Ordinary Meeting of Council

ITEM 9.1 DEVELOPMENT APPLICATION DA.2021.1453 -
CONSTRUCTION OF A THREE STOREY BOARDING
HOUSE - 2 ROSS ROAD, QUEANBEYAN

PROPOSED 24 ROOMS NEW GENERATION BOARDING HOUSE

Queanbeyan-Palerang Regional Council has requested to provide additional information concerning sewer, stormwater, architectural, and planning matters dated 10th December 2021.

Source: Extracted from revised Architectural plans (Ground Floor)

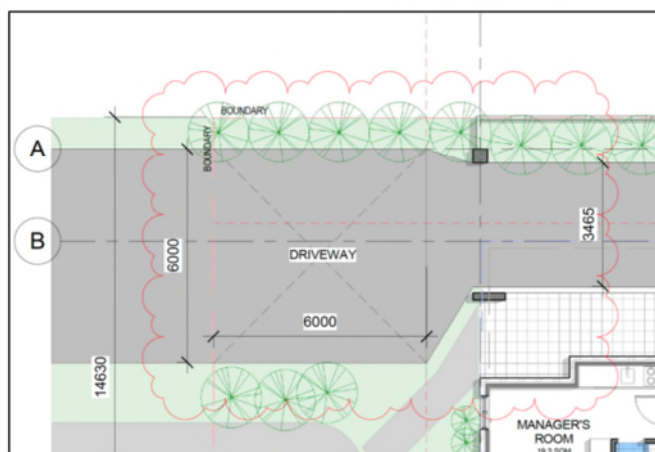
- Revised plans are required showing that the driveway access width is increased to 6m from the kerb to a point at least 6m within the property boundary to assist with safer site access and egress.

Driveway access has been adjusted to 6m from kerb to a point at least 6m within the property boundary to cater the safe site access and egress. (Refer to the below figure)
